Access Compliance Report

Public Rights-of-Way

Intersection ID: 52521	Main Street: LORNA_ST	Cross Street: MCCLINTOCK_RD	Location: SE
ADA ID: 53221797FB58	Ramp Type: BlendTrans1	Initial Pass/Fail: Pass	Overall Compliance: No
Severity Score: 0.25			
Codes/Mitigation Info/Possible Solution		Field Measurements/Component Compliance

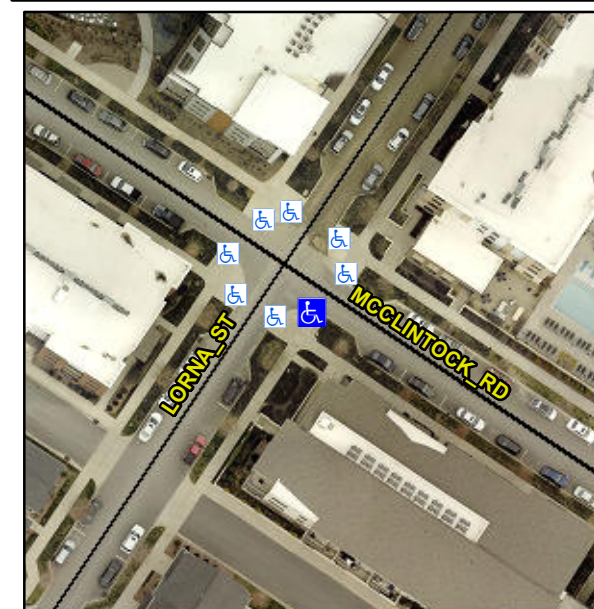
R304.5.3, R304.2.2-Perp, R304.3.2-Para, R305.2

Compliance	Description	Data	Compliance	Description	Data
N/A	Ramp Length (in)	76.0	Yes	BlendTrans Slope (%)	4.5
Yes	Ramp Width (in)	72.0	No	BlendTrans XSlope (%)	2.3
N/A	Flare Type LT	Sloped	N/A	Flare Type RT	Sloped
N/A	Flare Slope LT (%)	6.0	Yes	Flare Slope RT (%)	7.5
N/A	Flare Traversable LT?	No	N/A	Flare Traversable RT?	Yes
Yes	Landing Length (in)	71.5	Yes	DWS Provided?	Yes
Yes	Landing Width (in)	72.0	Yes	DWS Contrast?	Yes
No	Landing Slope (%)	3.9	Yes	DWS Length (in)	24.0
No	Landing X Slope (%)	2.3	Yes	DWS Full Width?	Yes
N/A	Landing Curb? (Y/N)	No	No	DWS Offset (in)	5.5
N/A	Shared Landing?	Yes			
Yes	Gutter Ponding?	No	Yes	Gutter Slope (%)	1.3
Yes	Gutter Lip Ht (in)	0.0	Yes	Gutter X Slope (%)	1.2
N/A	Painted X Walk1?	No	N/A	Painted X Walk2?	N/A
	X Walk 1 Direction	To NE		X Walk 2 Direction	N/A
	X Walk 1 Width (in)	N/A		X Walk 2 Width (in)	N/A
	X Walk 1 Slope (%)	1.2		X Walk 2 Slope (%)	N/A
	X Walk 1 X Slope (%)	1.3		X Walk 2 X Slope (%)	N/A

Remove & Replace Curb Ramp With Two New Directional Ramps or Equivalent.
